Public Relations Reroof – Addendum #1 Questions

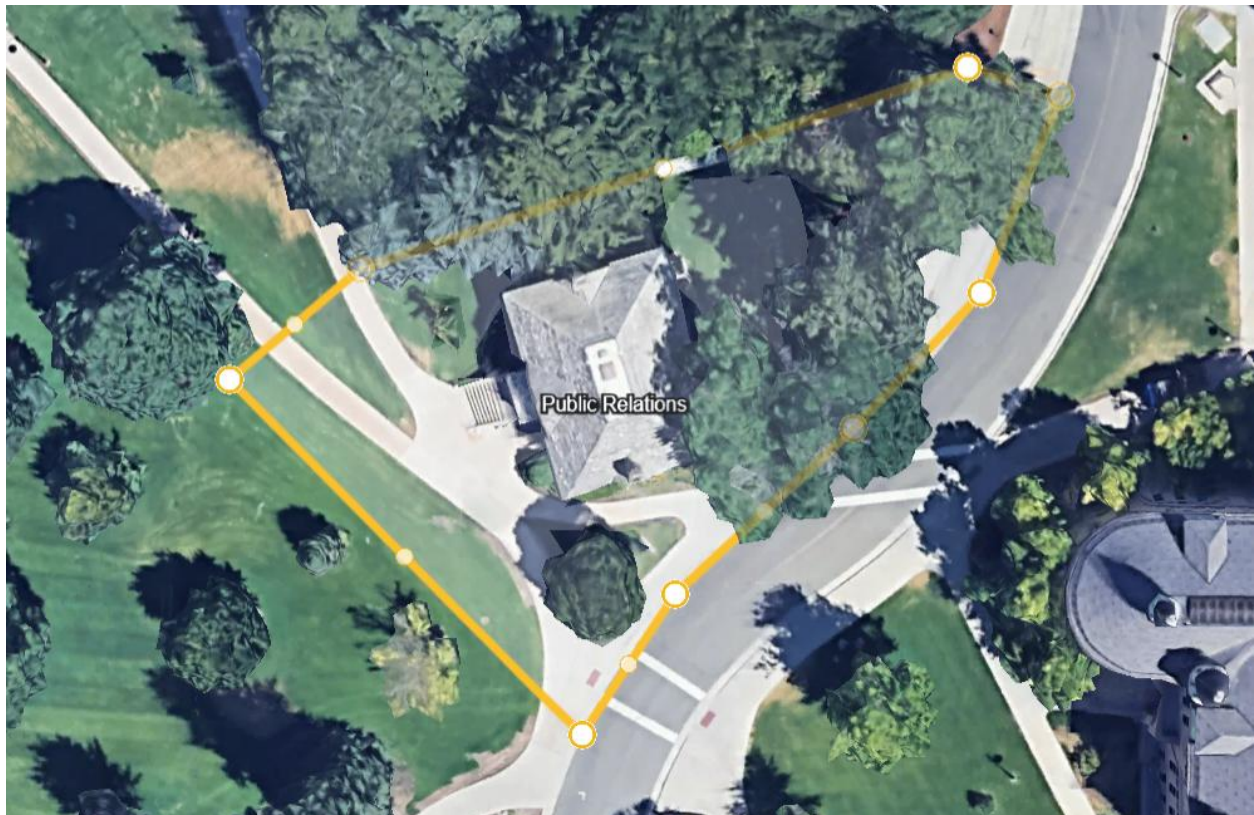
6. Can the highlighted area be used for the construction and staging area? Sidewalk signage can be installed to direct pedestrians around the site. **Exact area for staging will be discussed in the pre-construction meeting.**
